SUBJECT: DRAFT SAFETY EVALUATION FOR TOPICAL REPORT WCAP-15836-P,
"FUEL ROD DESIGN METHODS FOR BOILING WATER REACTORS -
SUPPLEMENT 1" (TAC NO. MB5740)

DRAFT SAFETY EVALUATION BY THE OFFICE OF NUCLEAR REACTOR REGULATION

TOPICAL REPORT WCAP-15836-P, "FUEL ROD DESIGN METHODS

WESTINGHOUSE ELECTRIC COMPANY LLC

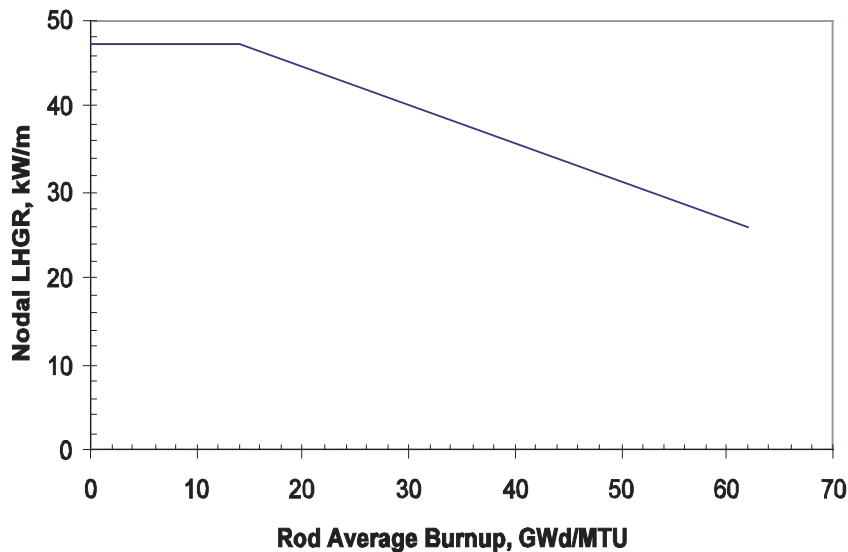
11 must meet the LHGR versus time duration used for analyzing AOO events. Based upon the
12 information presented in Reference 5 along with the PNNL technical assessment, the NRC staff
13 finds that STAV7.2 is applicable up to the nodal power profile depicted below.
14

15 The figure below illustrates the peak LHGR ≤ 47.3 kW/m from BOL to a rod average burnup of
16 14 GWd/MTU, then linearly decreasing to 26 kW/m at a rod average burnup of 62 GWd/MTU.
